COLAC OTWAY SHIRE COUNCIL PLANNING COMMITTEE MEETING

PA2403395-2-4 and 6 Miller Street, Colac - Submission and Planning Application to Minister of Planning

ADDRESS AND PROPERTY DETAILS	2-4 & 6 Miller Street, Colac (Crown Allotments 1, 2 & 3 Section 48)	APPLICATION NUMBER	PA2403395
PROPOSAL	Use and Development of the Land for Group Accommodation		
PERMIT TRIGGERS	Clause 32.08-2 – General Residential Zone (GRZ1) - Use of the land for accommodation (group accommodation). Clause 32.08-10 – General Residential Zone (GRZ1) - Construction of a building or construction or carrying out works for a use in Section 2 (permit required) of Clause 32.08- 2.		
TRIGGER FOR DETERMINATION BY COMMITTEE	Submission on Planning Application to Minister of Transport and Planning		
ZONE	General Residential Zone (GRZ1)	OVERLAYS	Nil
COVENANTS	Crown Grant only, relating to mining rights. The proposal would not result in a breach of the covenant.		
CULTURAL HERITAGE	N/A		
OFFICER	Bernadette McGovan	GENERAL MANAGER	Ian Seuren
DIVISION	Community and Economy		
ATTACHMENTS	1. Plans [7.1.1 - 14 pages]

SHADOW 3PM
SCALE 1 : 200

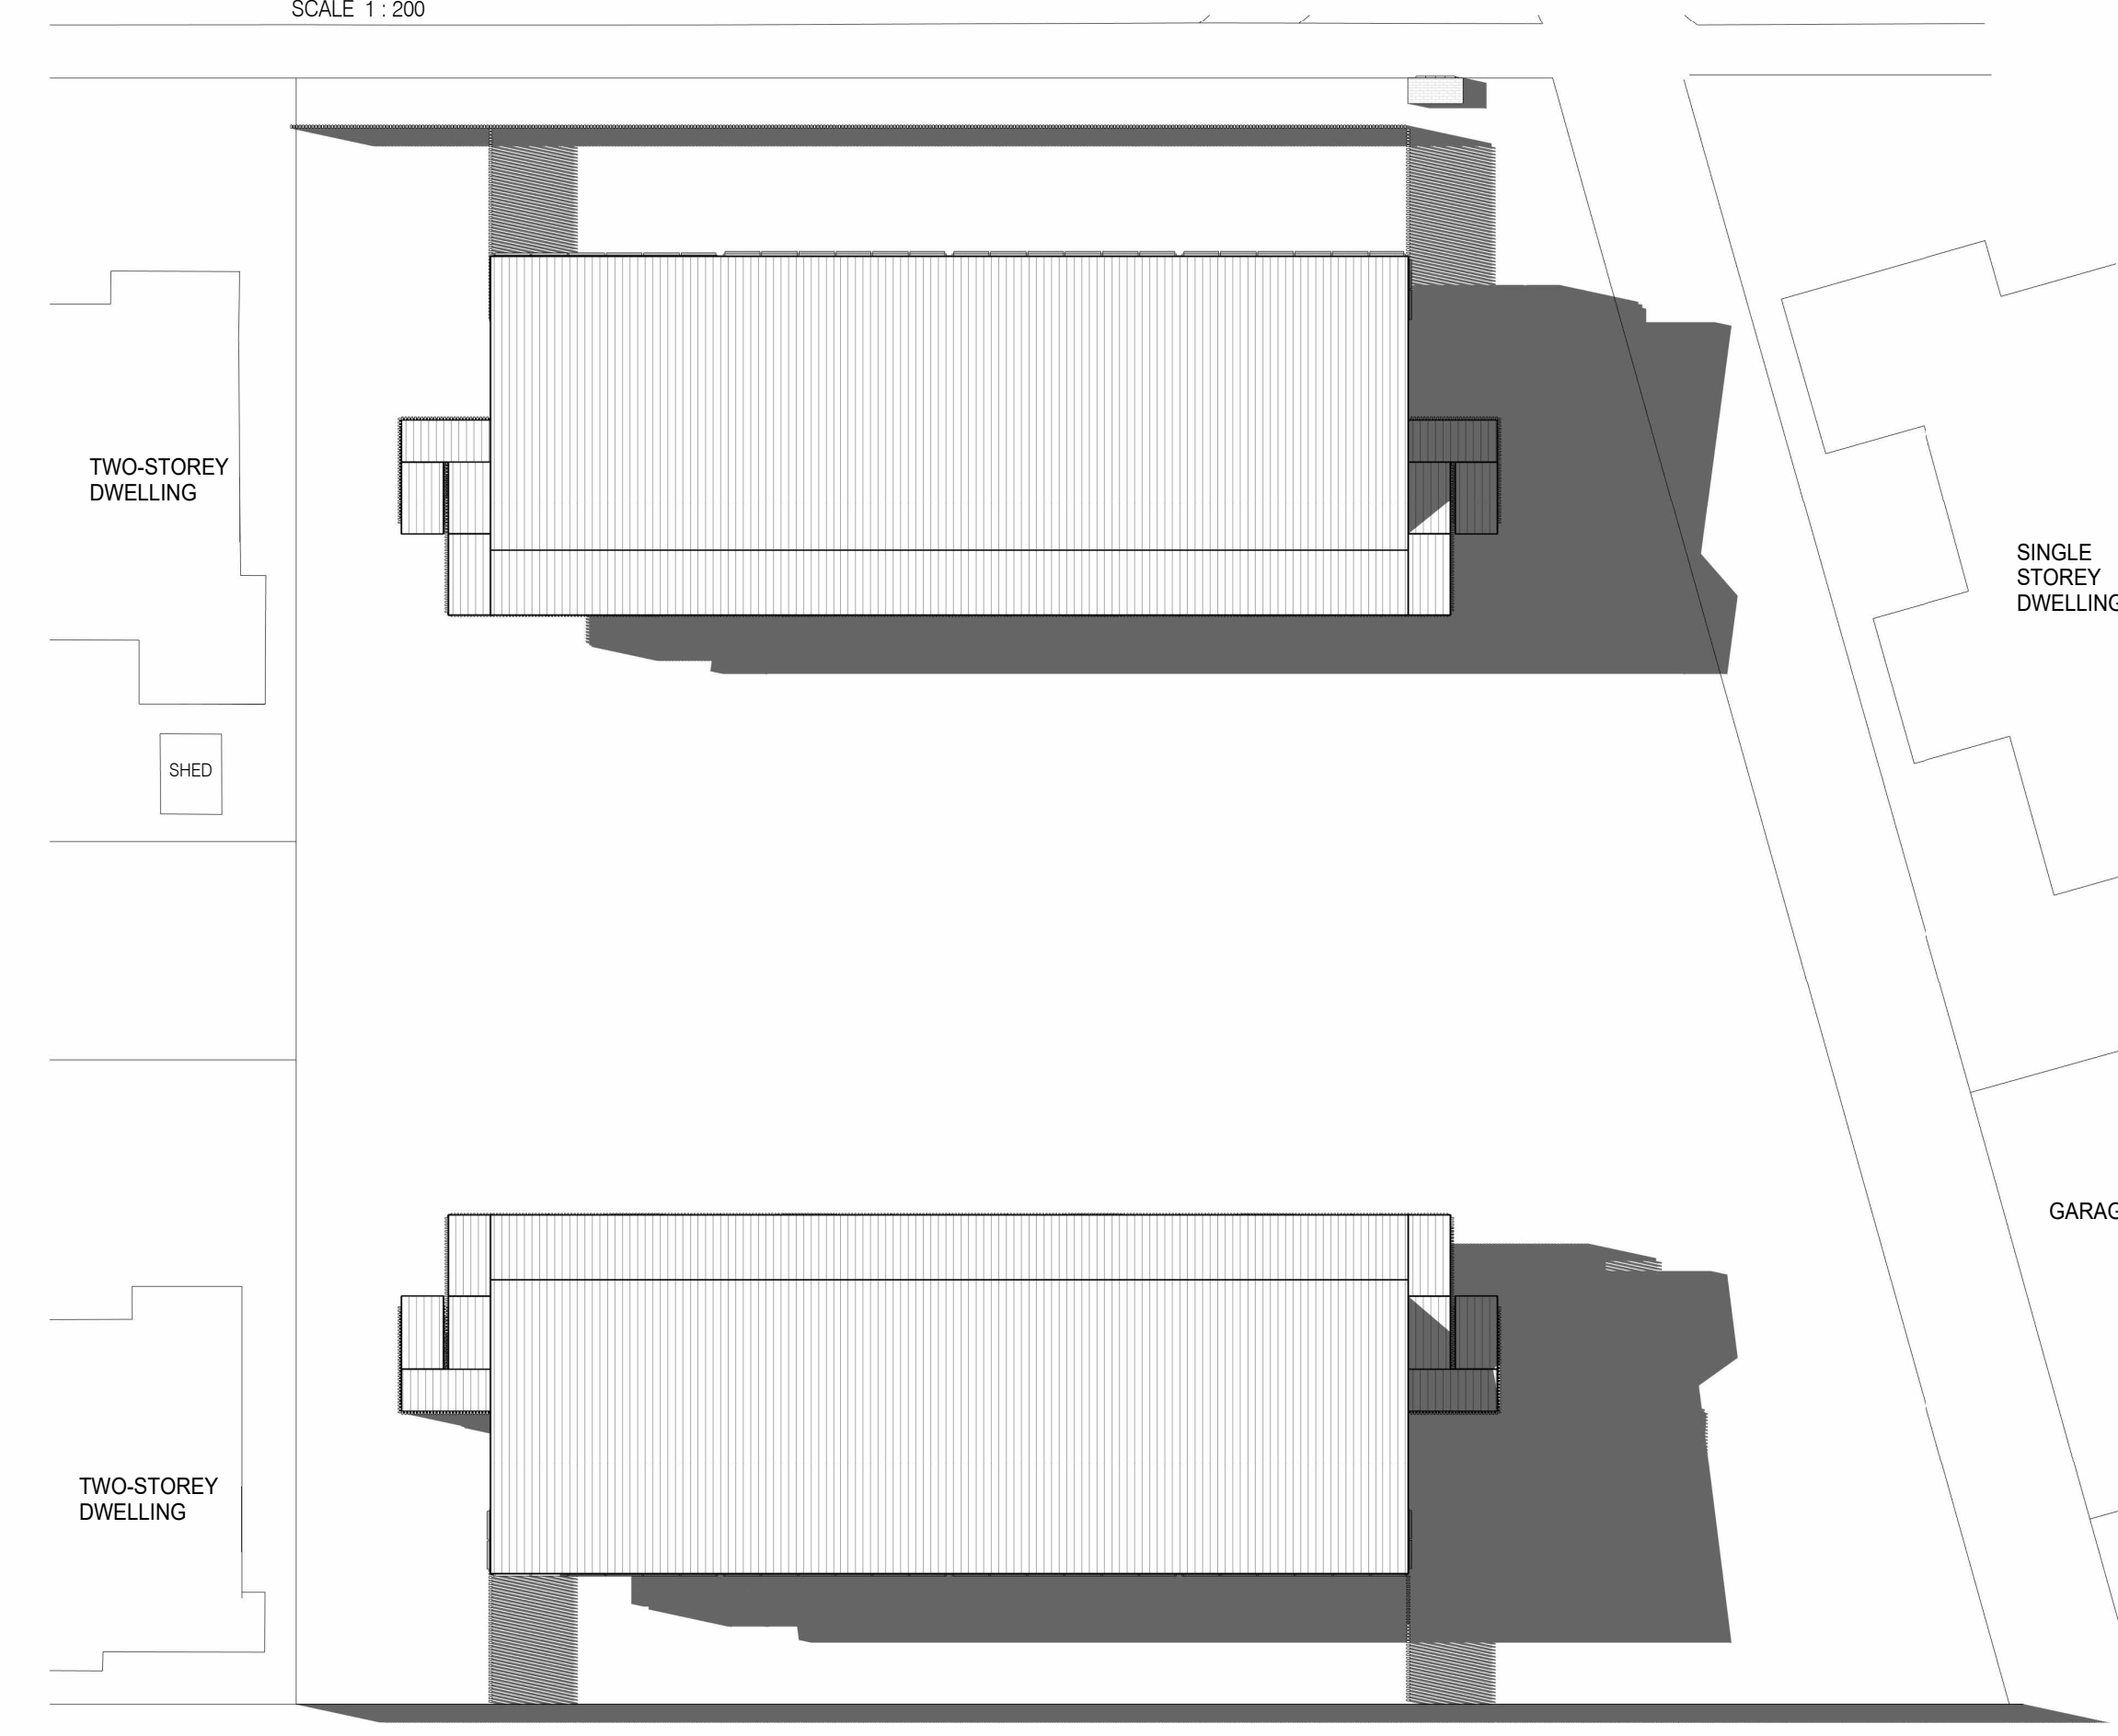
Shadow diagrams demonstrate that there would be no shading of adjoining existing private open space areas, particularly given separation provided by laneways. It is noted that the ground level courtyards to the south building would be largely shaded until 3pm on 22 September (a measure required to be assessed under the planning scheme); however, the applicant does not intend to revise the design to address this on the basis that *“reasonable amenity is provided for temporary residents of the southern units. We note the development includes communal open space which has excellent solar access and will be accessible to all residents”*.
